September 10, 1984

HOPE CREEK GENERATING STATION DOCKET NO. 50-354 POWER SYSTEM BRANCH

Pursuant to the meetings held on September 6 and 7, 1984, with R. Giardina of the Power System Branch (PSB), the responses to PSB Open Item 23 and the FSAR Questions listed in Attachment 1 have been revised and are enclosed for your review and approval (See Attachment 2).

### QUESTION 430.135 (SECTION 9.5.7)

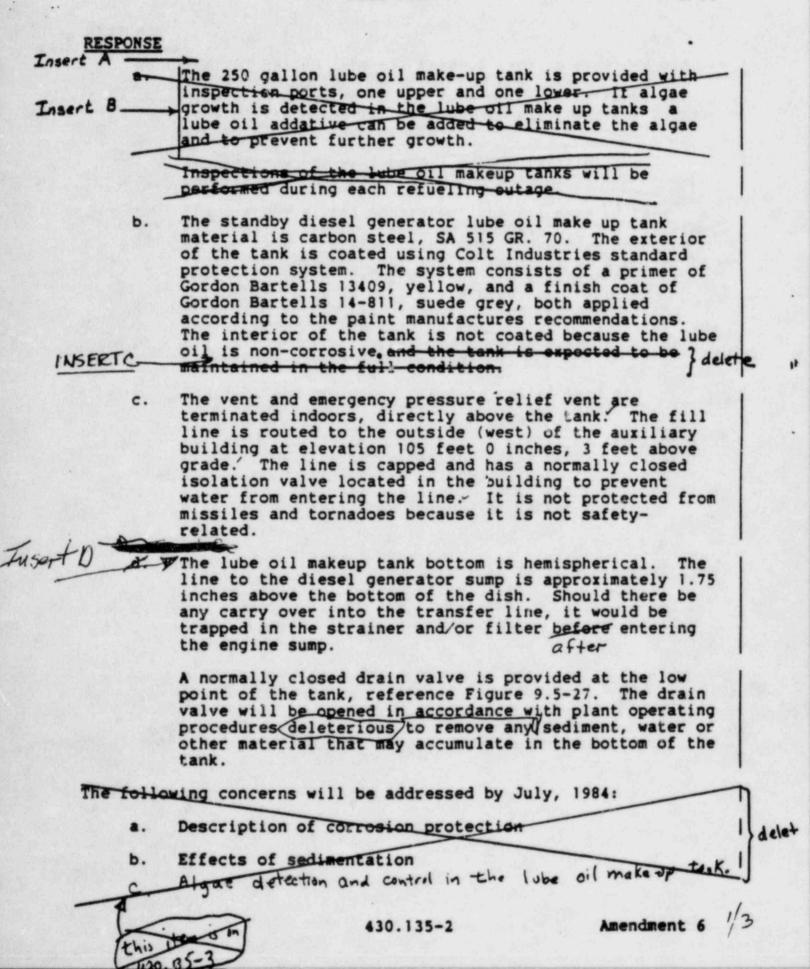
You state in Section 9.5.7.2 of the FSAR and shown in Figure 9.5-27 that lube oil is added to the diesel generator lubricating oil system from a 250 gallon lube oil make-up tank. Provide a discussion on the measures that have been taken to prevent entry of deleterious materials in the lube oil make-up tank. Also discuss what measures have been taken to prevent entry of deleterious materials into the lube oil make-up tank due to operator error during filling operation.

- c. Figure 9.5-27 of the FSAR shows that the diesel generator lube oil make-up tank is provided with an individual fill, vent, and emergency pressure relief vent lines. Indicate where these lines are located (indoor or outdoor) and the height these lines are terminated above finished ground grade. If these lines are located outdoors discuss the provisions made in your design to prevent entrance of water into the makeup tank during adverse environmental conditions, and the tornado missile protection provided.
